AMENDMENTS TO THE DRAWINGS

REMARKS

This paper is responsive to the Non-Final Office Action dated August 26, 2004. Claims 1-28 were examined. The drawings are objected to under 37 C.F.R. § 1.83(a). Claims 9, 16-18, 25, and 26 are objected to under 35 U.S.C. § 112, second paragraph. Claims 1-11, 13-15, 18-20, and 23-28 stand rejected under 35 U.S.C. § 102(e) as being anticipated by U.S. Patent No. 6,707,318 to Kumar et al. Claims 12, 21, and 22 stand rejected under 35 U.S.C. § 103(a) as being unpatentable over Kumar in view of U.S. Patent No. 6,542,006 to Sprague et al.

FIG. 4

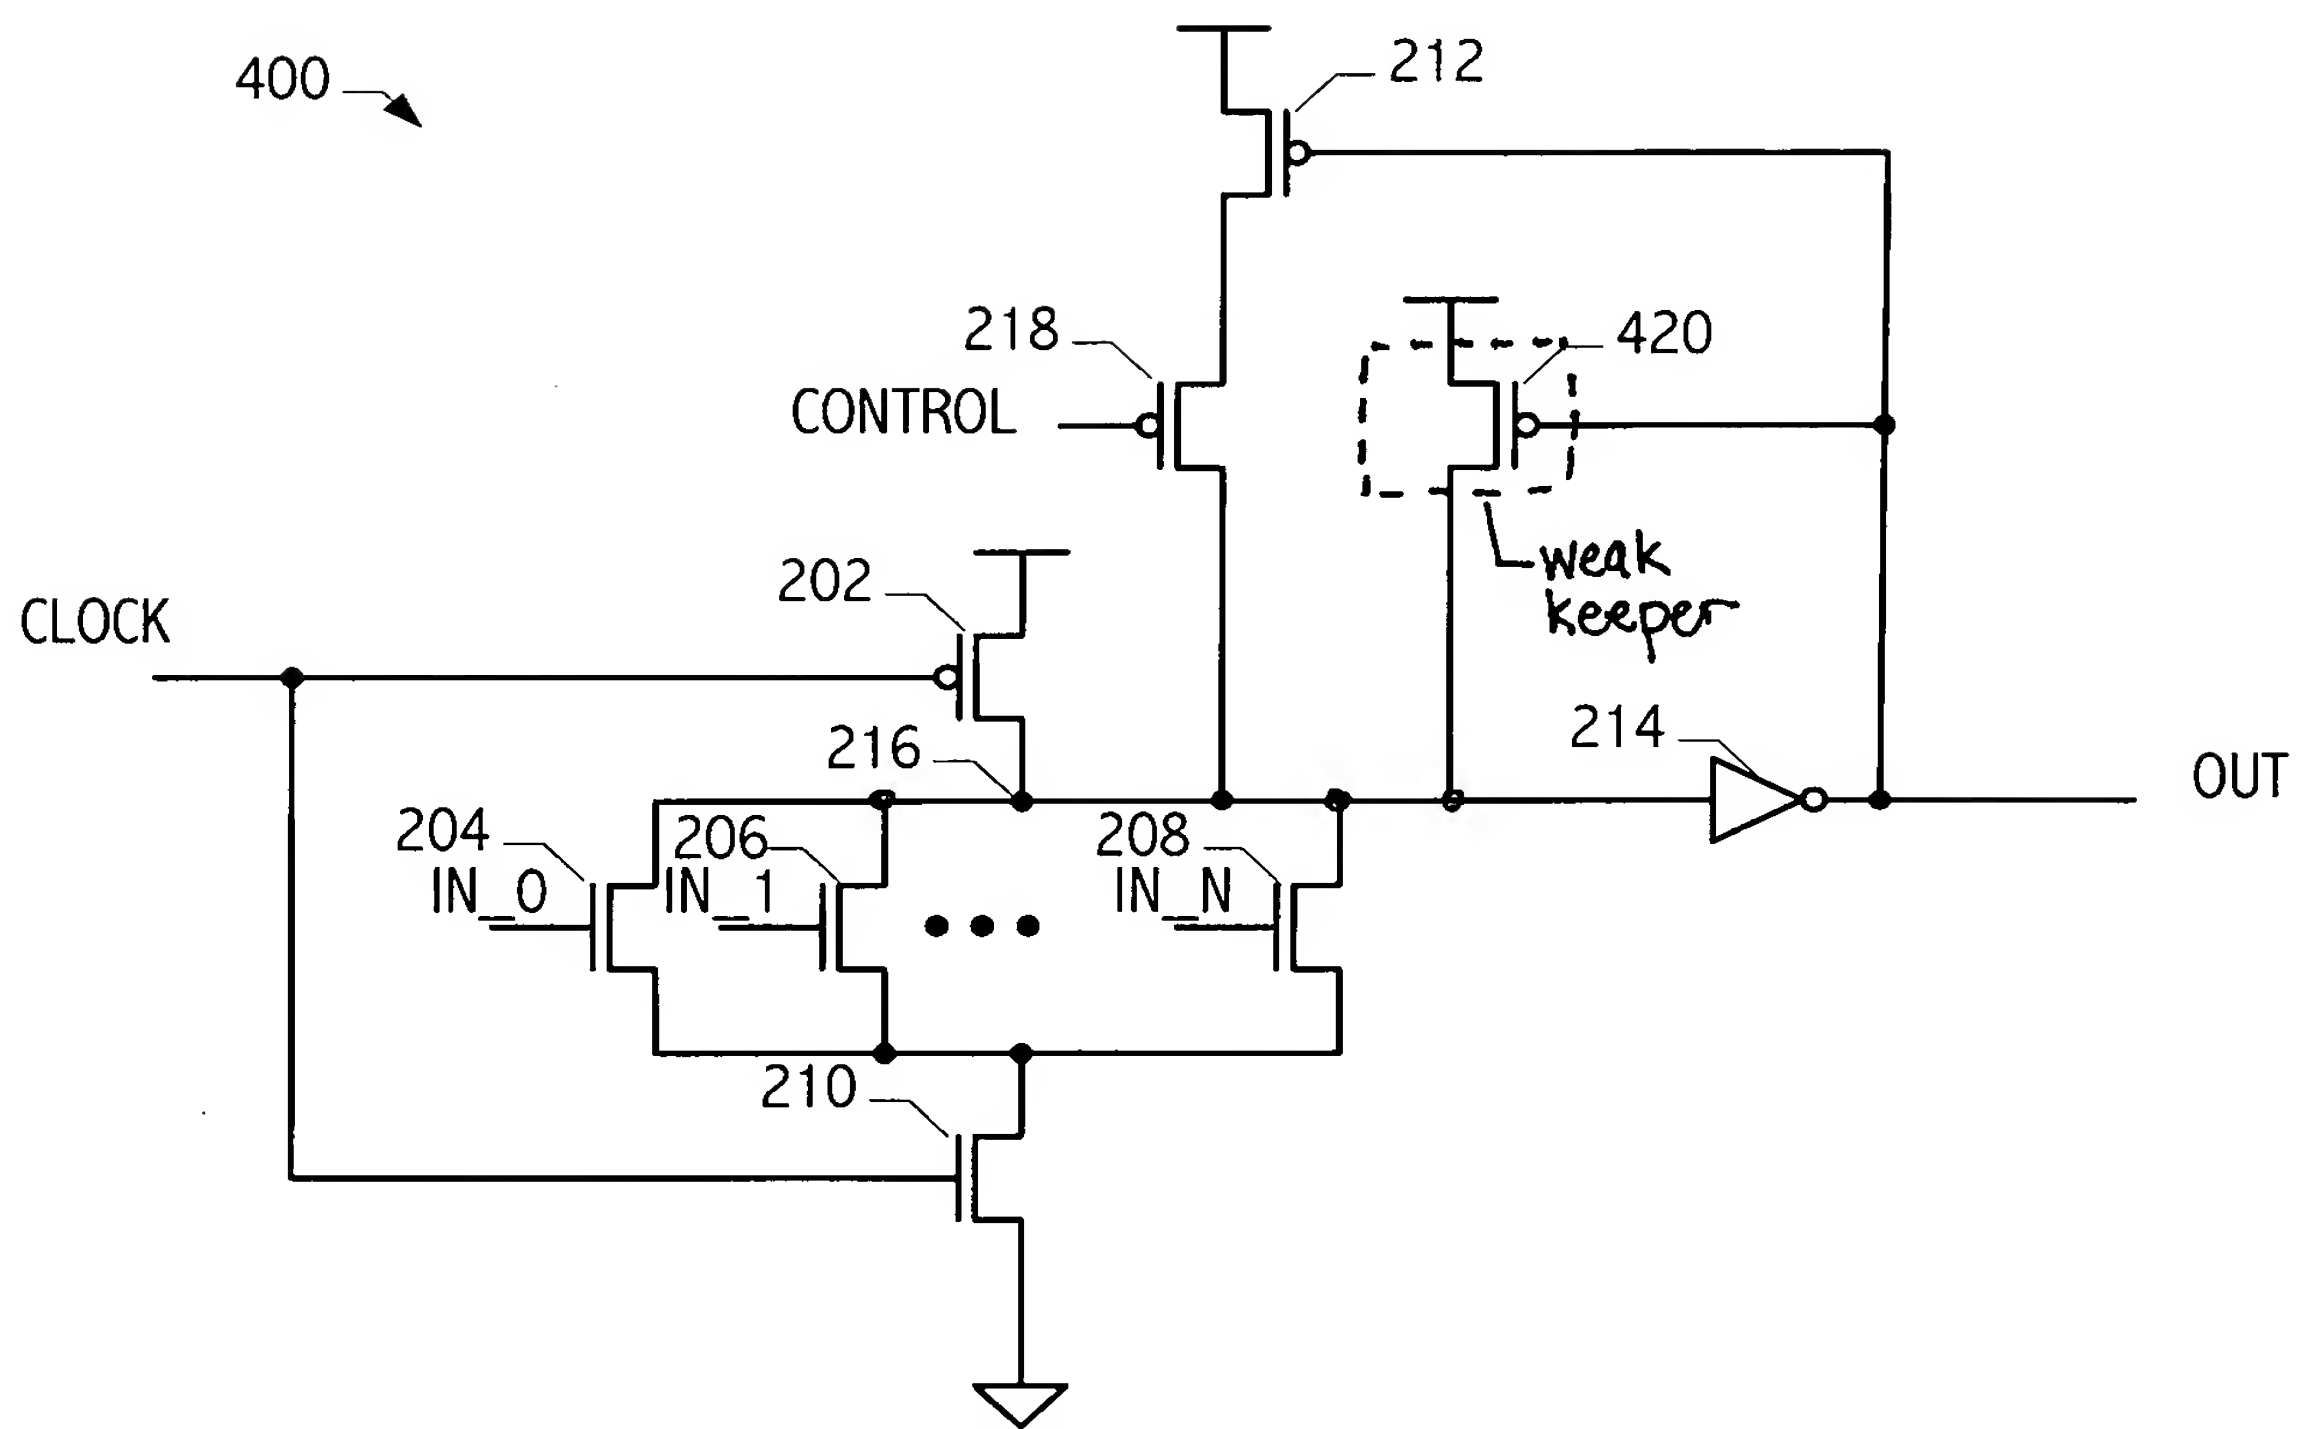
The drawings are objected to under 37 C.F.R. § 1.83(a) for failing to show every feature of the invention specified in the claims. Figure 4 has been amended to indicate that weak keeper 420 is a weak keeper. This amendment is supported at least in the specification at page 6, paragraph 1022. No new matter is added. In addition, Figure 4 was amended to clarify the connections between pull-down devices 206 and 208 to dynamic node 216 and to clarify the connection between weak keeper 420 to dynamic node 216. Figure 5 has been added to illustrate that the dynamic node is precharged low and the evaluation circuit is p-logic. Figure 5 is supported at least by paragraph [1026] in the specification as filed on June 27, 2003 and originally filed claims 21 and 22. No new matter is added.

The attached sheet(s) of drawings include changes to Fig. 4 and new Fig. 5 replaces the original sheet(s) including such figures.

Attachment(s): Replacement Sheet including amended Fig. 4 and new Fig. 5; and
 Annotated Sheet Showing Changes to amended Fig. 4.
